TENDER ADDENDUM NO. 1

Client China Life Insurance Address 25F CLI Building,
313 Hennessy Road, Wan Chai

Project No. P26-25 **ADDENDUM**

Drawing Name LIGHTING PLAN Drawing No. 15 EL-01-03

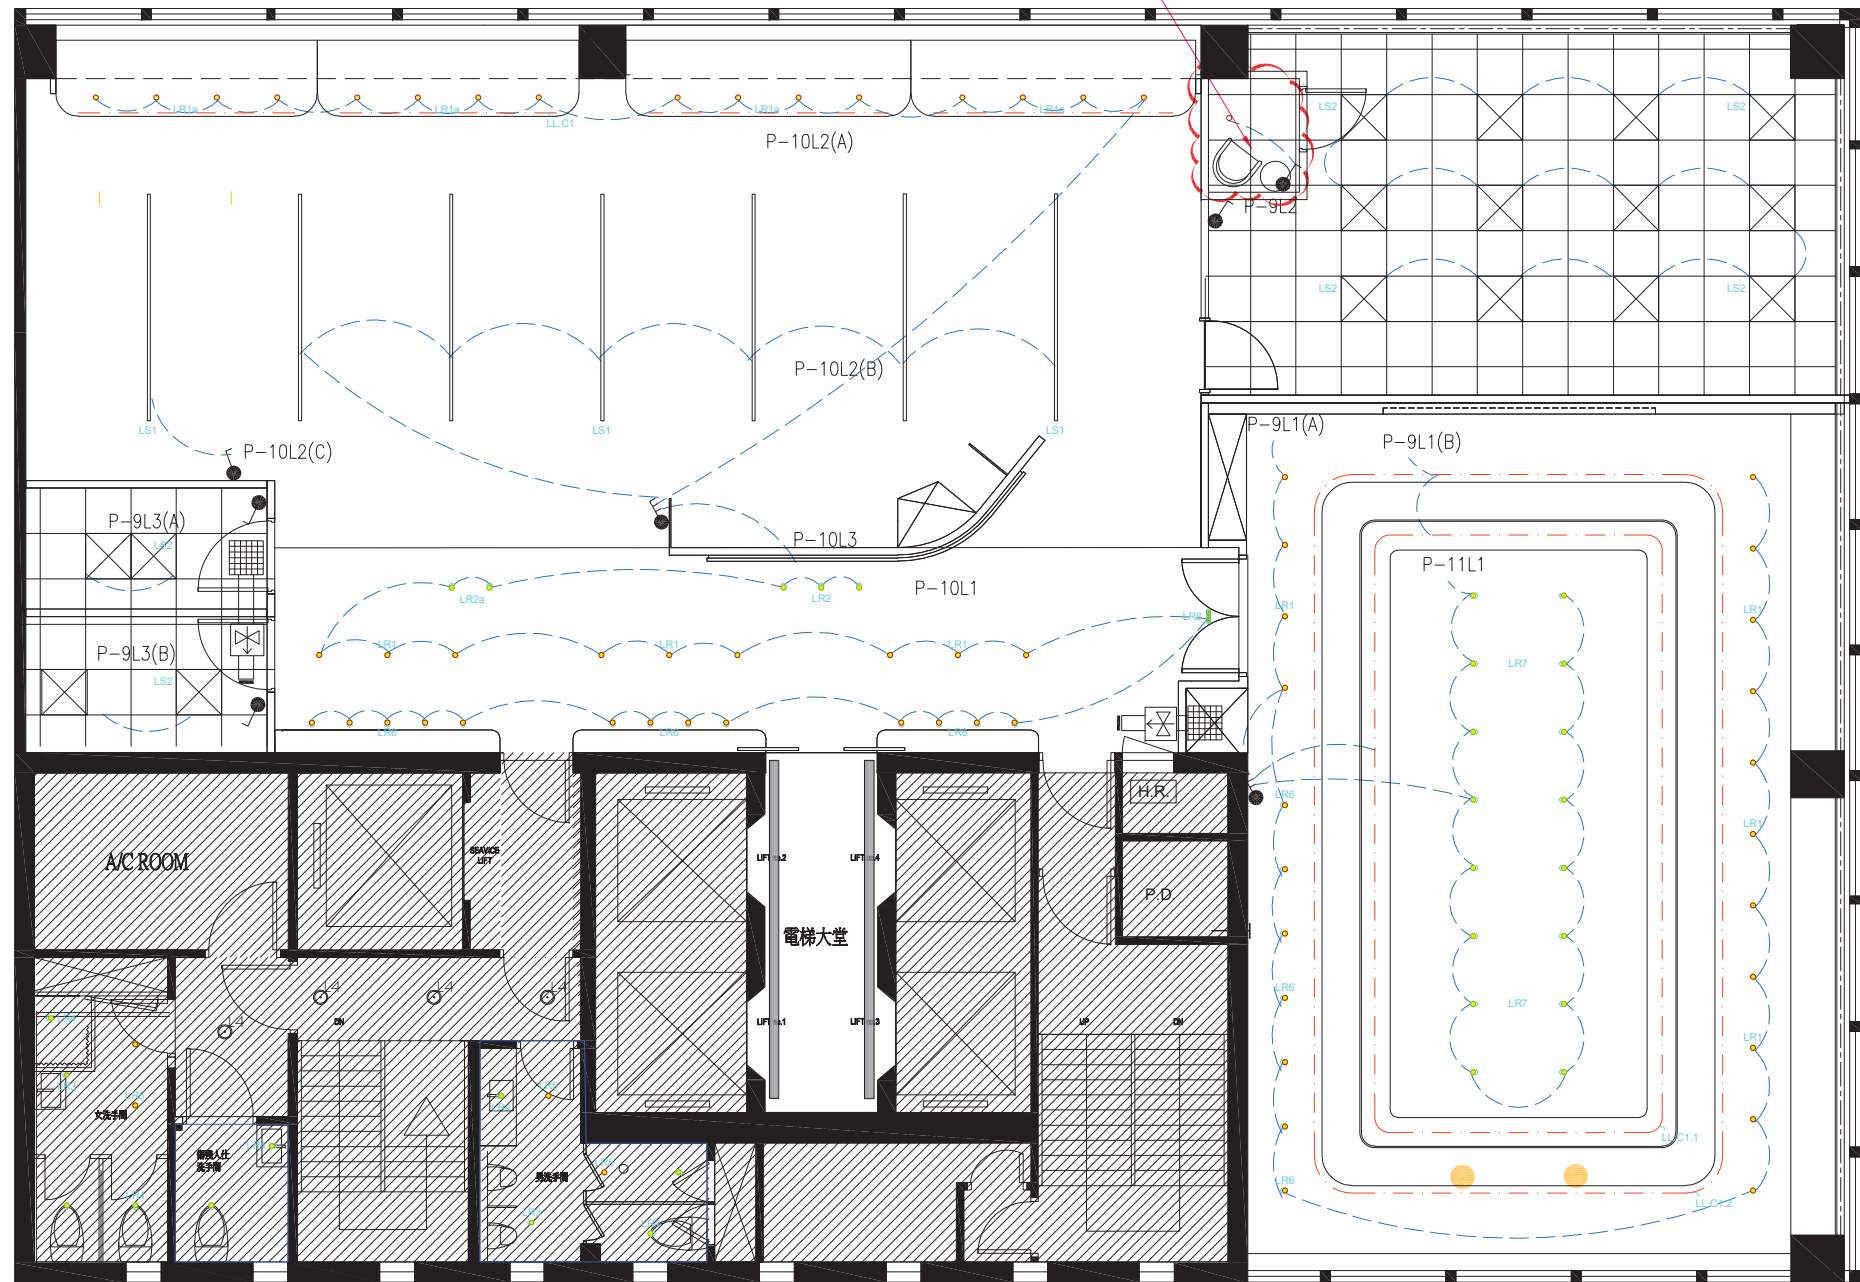
ADDITION I NO LIGHTING AND LIGHT SWITCH
